PLANNING COMMISSION STAFF REPORT

Meeting: February 24, 2026

The project consists of the following applications: 1) a Hillside Exception for grading on slopes exceeding 30% in order to create several flat yard areas, 2) an R-1 Exception for garage design, 3) a Design Review Permit for a new two-story residence with second-story side setbacks of less than 15 feet and a second to first floor area ratio exceeding 66%, 4) a Minor Residential Permit for a balcony, and 5) a Tree Removal Permit for the removal and replacement of five Protected native oak trees (ranging in size between 12-inches DBH to 18-inches DBH) to allow the creation of the flat yard areas. (Application No(s): EXC-2025-007, EXC-2025-008, R-2024-029, RM-2024-028, TR-2024-043; Applicant(s): David Kuoppamaki; Location: 22068 San Fernando Court; APN(s): 357 12 012) ¹

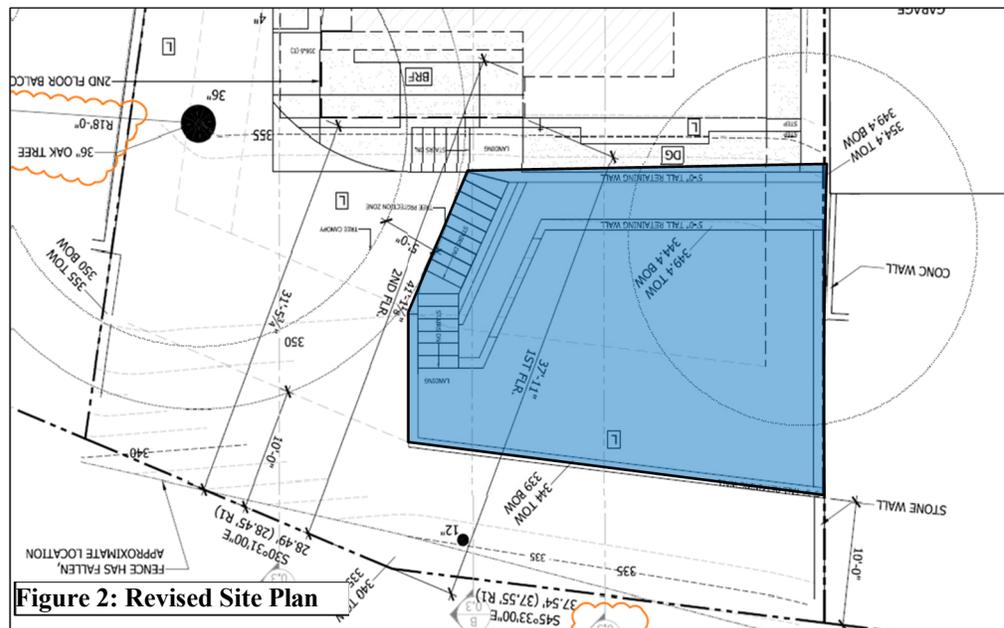
The initially proposed design posed concerns related to over-grading the site, drainage and runoff, the visual impact of retaining walls from the adjoining Blackberry Farm Park, and potential disturbance and compaction within the root zone of the 36-inch oak tree that is to be retained. While understanding that the applicant wishes to have a flat yard area, to address the concerns identified the applicant worked with staff to revise the rear yard design. The proposed smaller flat rear yard area is limited to the area bounded by a 10-foot setback from the rear property line and a five-foot setback from the 36-inch oak tree dripline as indicated in Figure 2 below. The required 10-foot setback from the rear property line will allow for drainage and runoff requirements to be met onsite. In addition, the applicant is proposing that the visible height of any retaining walls not exceed five feet. Staff recommends approval of the modified Hillside Exception request to allow the smaller usable flat rear yard area, with a five-foot limitation on the height of any proposed retaining walls. With these changes, staff believes that the previous concerns identified are alleviated.

The light blue area in Figure 2 indicates the approximate area (~1,000 sq. ft.) in which the flat rear yard area would be located, a reduction of approximately 50 percent from the original proposal which

included over 2,000 square feet of site work. Additionally, while the property is mostly screened by existing trees along Stevens Creek Trail, the setback will provide for an additional area between the retaining walls and the trail, where replacement trees will be planted, therefore reducing potential visual impacts when viewed from the trail.

Staff is recommending approval of the removal of four of the five protected oak trees to accommodate the modified flat yard area, except one 12-inch oak tree located at the base of the sloped area which can be reasonably protected through the proposed grading design with a 10-foot rear setback. The project has also been conditioned to provide replacement trees, with an added requirement that, to the extent possible, replacement trees be planted in the rear setback to add to the landscape buffer between the property and the trail. Should the Commission not approve the Hillside Exception, staff recommends denial of the Tree Removal Permit.
